Subject: McGuire Nuclear Station  
Docket Nos. 50-369 and 50-370  
Release of Radioactivity from the Conventional  
Wastewater Treatment System

Subject: McGuire Nuclear Station  
Docket Nos. 50-369 and 50-370  
Technical Specification Amendment  
Release of Radioactivity from the Conventional  
Wastewater Treatment System

The proposed change to the Technical Specification is concerned with Section 5.0, Design Features. The proposed change to this section would show a second potential radioactive liquid effluent release point on Figure 5.1-4.

ATTACHMENT IV

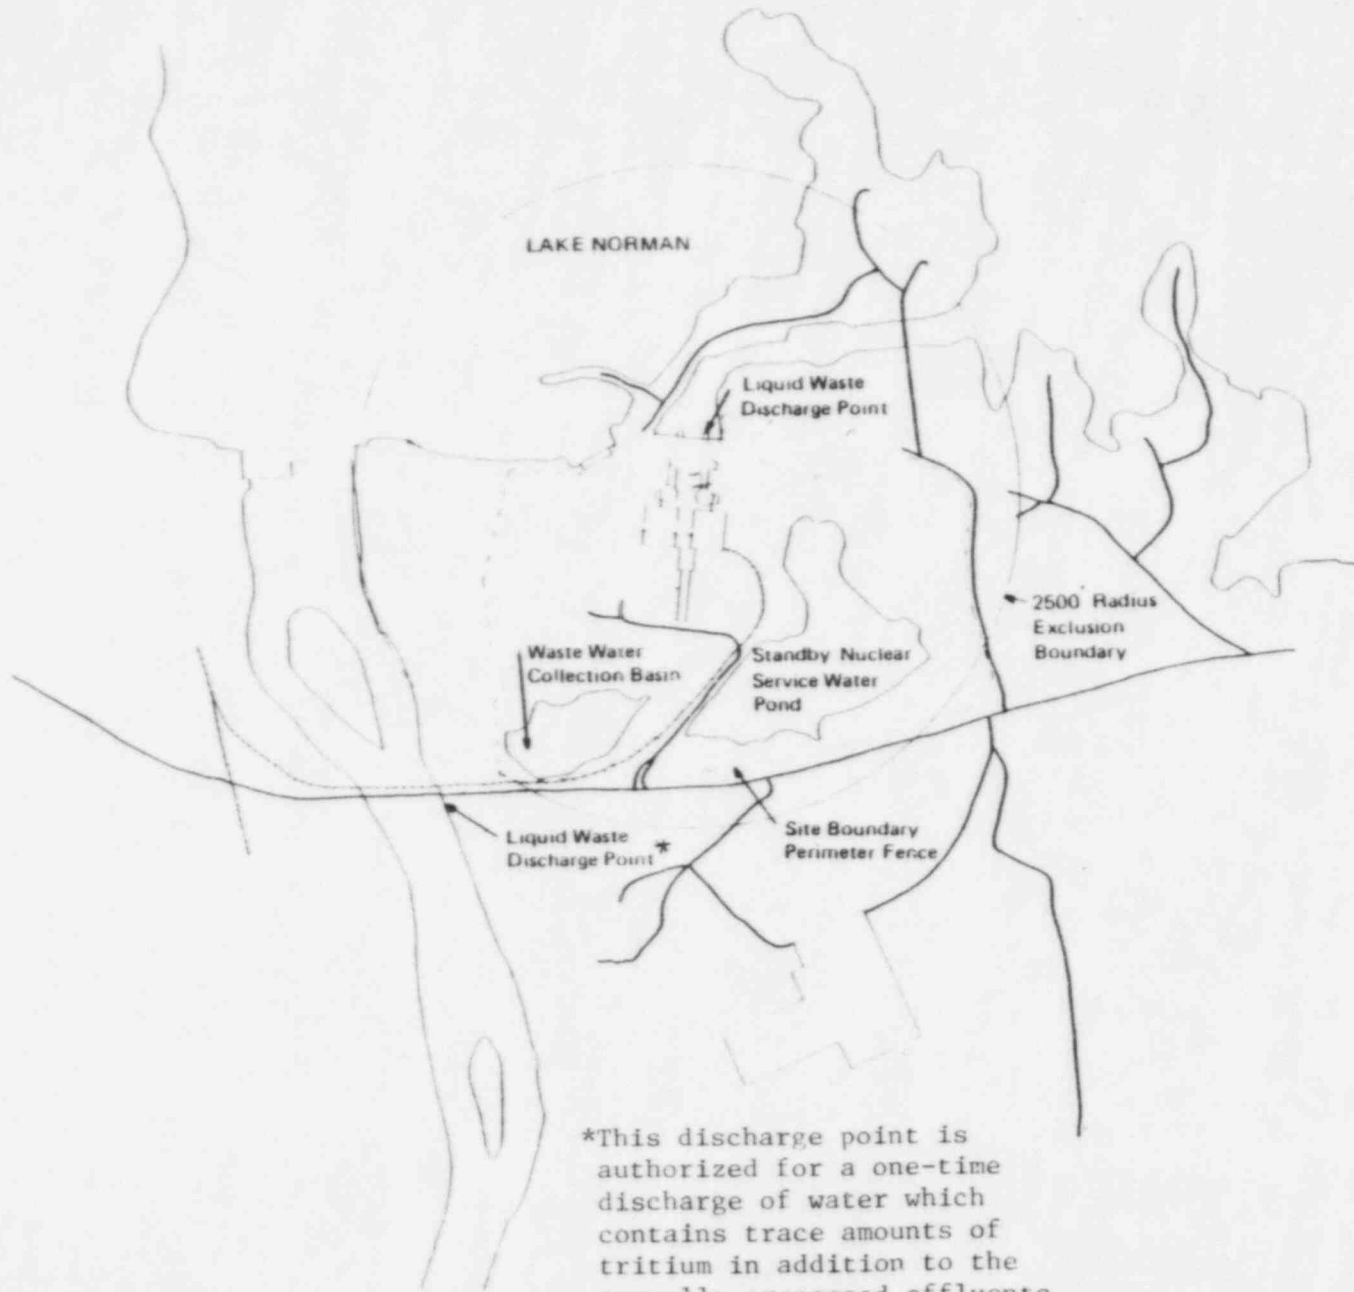
- Due to the limited and temporary scope of this change, Figure 5.1-4 of Attachment I is reproduced as Attachment IV with an appropriate caveat identifying the applicability of the change.

\*This discharge point is authorized for a one-time discharge of water which contains trace amounts of tritium in addition to the normally processed effluents of the Waste Water Collection Basin, effective \_\_\_\_\_

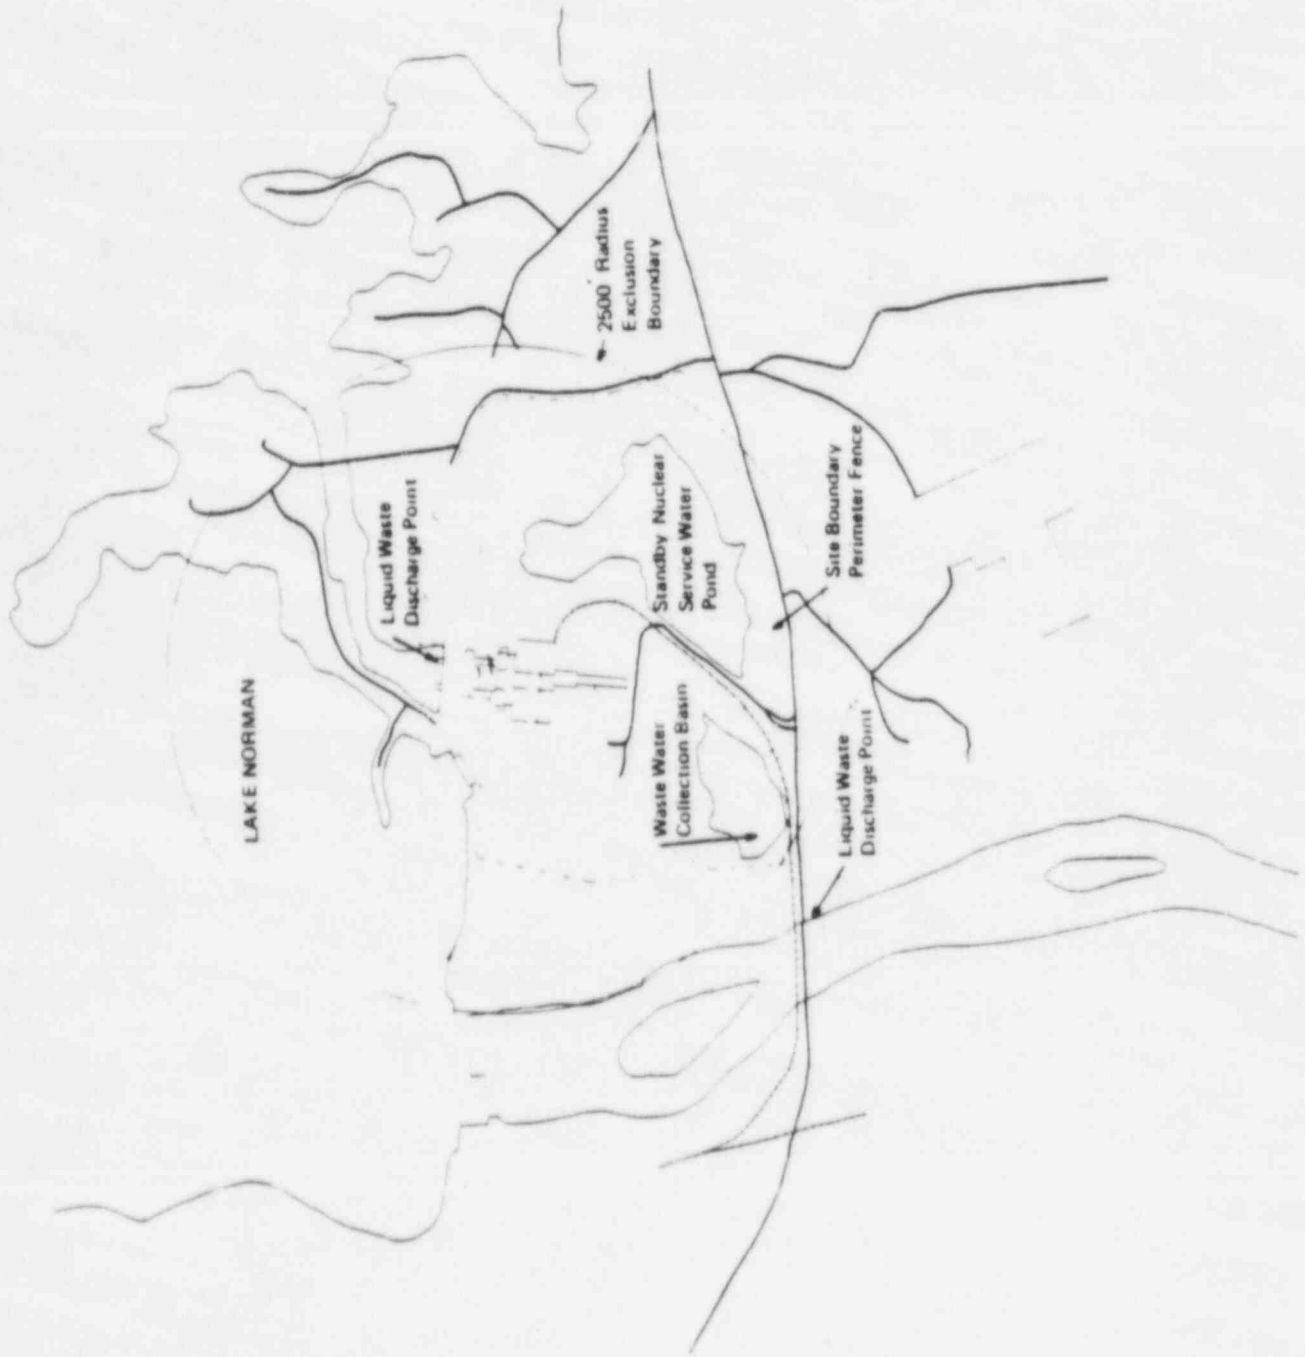
The proposed change to the McGuire Technical Specifications, Section 5.0, Design Features, incorporates a second potential radioactive liquid effluent release point on Figure 5.1-4.

The proposed revision consists only of a figure change to show an additional potential radioactive effluent release point, to more accurately reflect station design and practice when operating with a primary to secondary steam generator leak.
